# Moolarben Coal Complex UG2 Modification

## SUBMISSIONS REPORT

MCO is proposing to modify the Stage 2 Project Approval (08\_0135) to incorporate adjustments to the mine layout for the approved underground mine “UG2” (hereafter referred to as the UG2 Modification [the Modification]). A Modification Report was submitted in December 2021 to support this proposal under section 4.55(2) of the EP&A Act.

On 21 December 2021, DPE requested that MCO prepare and submit a Submissions Report for the Modification (this Report). Accordingly, this Submissions Report provides MCO’s responses to issues raised in submissions on the Modification. It has been prepared in consideration of the *State significant development guidelines – preparing a submissions report* (DPIE, 2021).

Figure 1 Predicted inflows to the UG2 mining area (with and without the Modification)

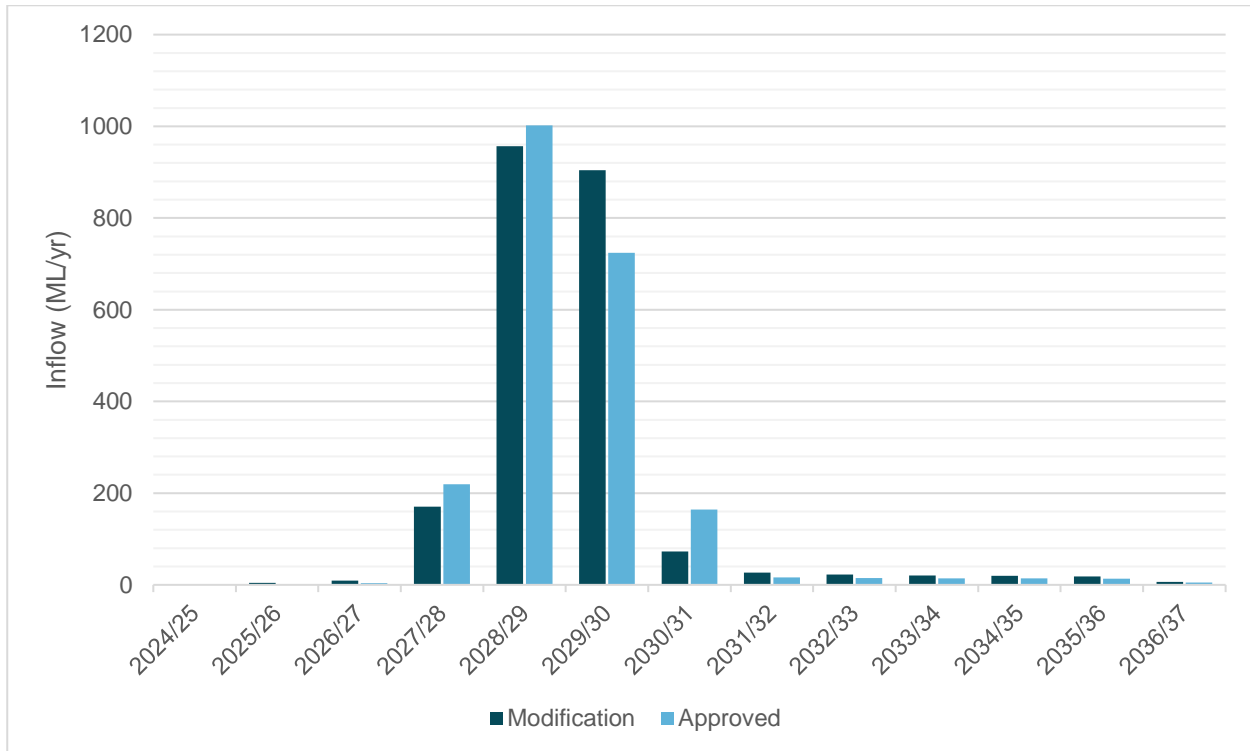
The Modification would result in an increase in the peak inflow to the UG2 mining area of 180 megalitres per year (ML/year) in water year 2029/30.

**Figure 2** – Drawdown predicted at the end of mining at the base of the Permian overburden due to the Modification (After Figure 5 of AGE, 2022b).

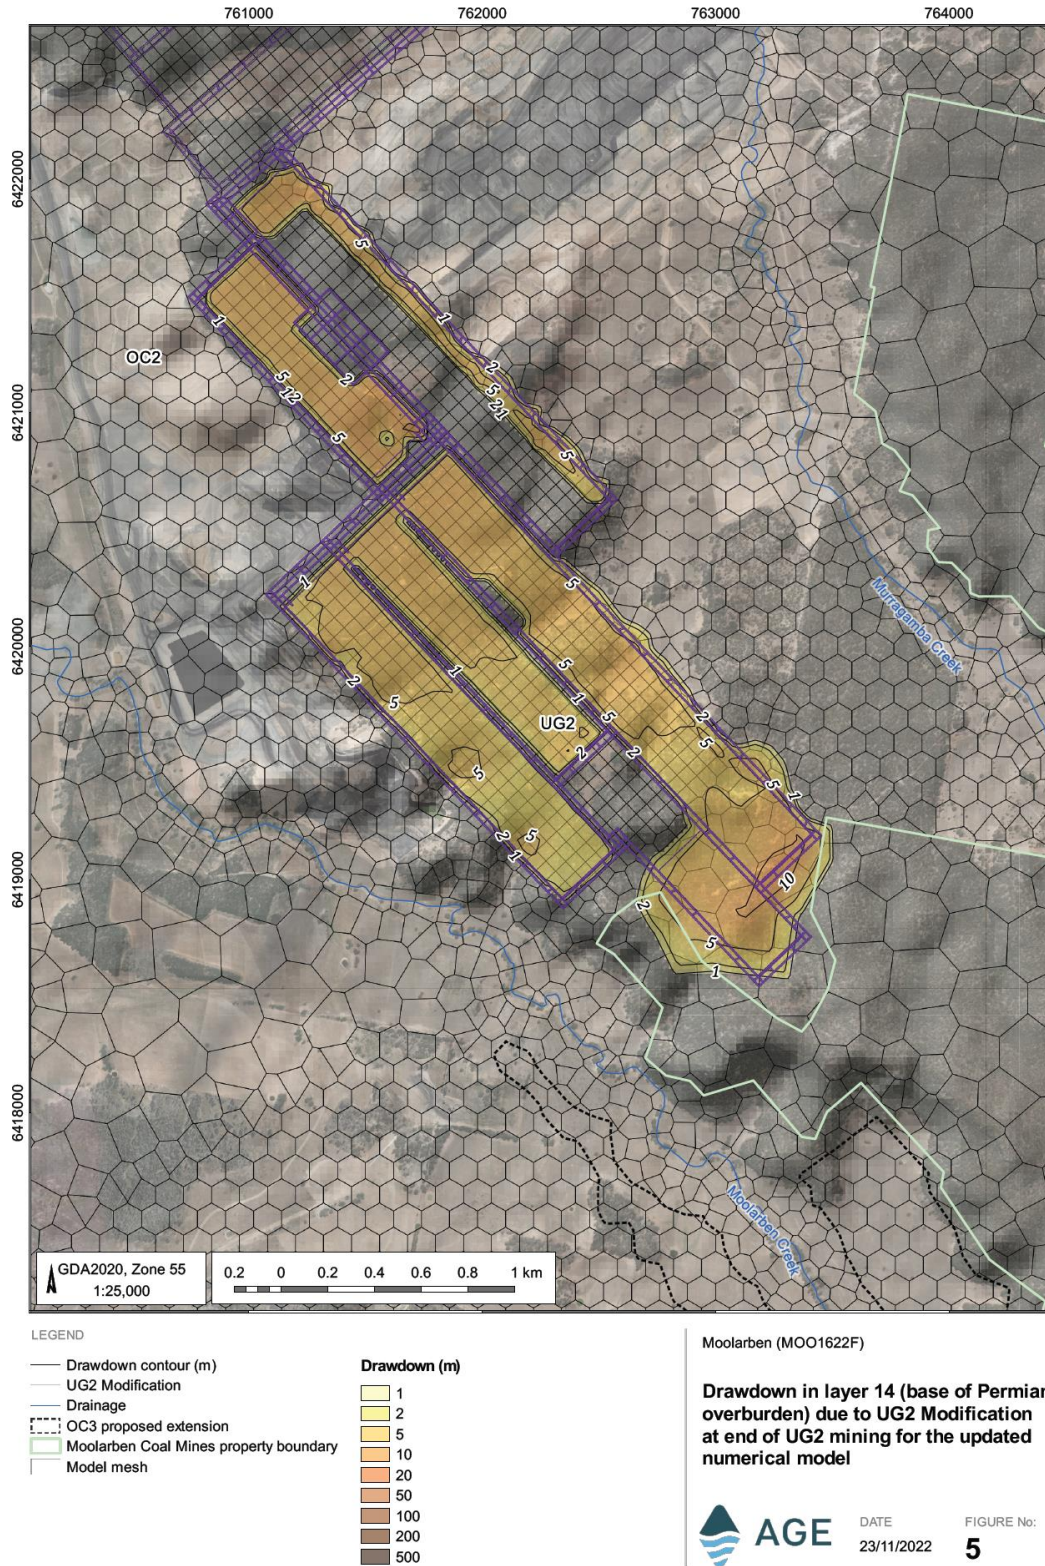
Predicted drawdown caused by the UG2 Modification is greatest in model Layer 14 at the base of the Permian overburden with a maximum of about 10 m drawdown expected in a small area above the extended UG2 workings. This can be seen in Figure 2 below. The figure illustrates the model calculation mesh is less refined in the area of the UG2 extension to the southeast of the currently approved UG2. It is interesting to note that the drawdown during mining is predicted to spread marginally more in the coarser model elements than in the finer elements that encompass the approved UG2 mining extent. The result suggests the marginally greater drawdown impacts predicted in the area of coarser elements is a modelling artefact. Figure 3 shows the predicted drawdown at the end of mining caused by all approved mining operations. When the drawdown caused by the UG2 Modification shown in Figure 2 is compared with the predicted drawdown when all currently approved mining is considered, as shown in Figure 3, it can be seen that the additional impact of the Modification is negligible.
